10/533,366

Office Action Summary

DETAILED ACTION

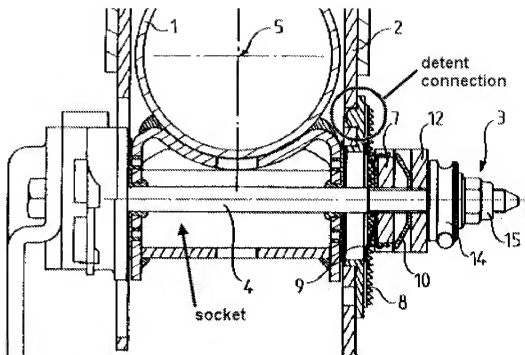
7. Regarding **claim 13**, Fevre discloses a device comprising: a guide part (bracket 12) which is prefitted on the fixing region of the guide rail (second member 2) and is

connectable to the door body and which receives a first part (clamping pin 4) of the multi-part fixing device, further comprising a device (mobile rack 7) for aligning the fixing region of the guide rail to the guide part and to the door body at least in the direction of the vehicle transverse axis (Y-axis) and a second part (nut 15) of the fixing device to produce a clamping connection between the fixing region of the guide rail and the door body, and a detent connection (see figure below) which engages in a nominal position of the guide part relative to the fixing region of the guide rail, the detent connection comprising an opening provided in an angled edge zone of the fixing region of the guide rail and a detent catch of the guide part engaging in the opening and having a ball head which engages in the opening of the fixing region of the guide rail.

10. Regarding **claim 21**, the fixing device comprises a connection of a fixing screw (clamping pin 4) and a fixing nut (nut 15); wherein the fixing screw is held in a socket as shown in the figure below.
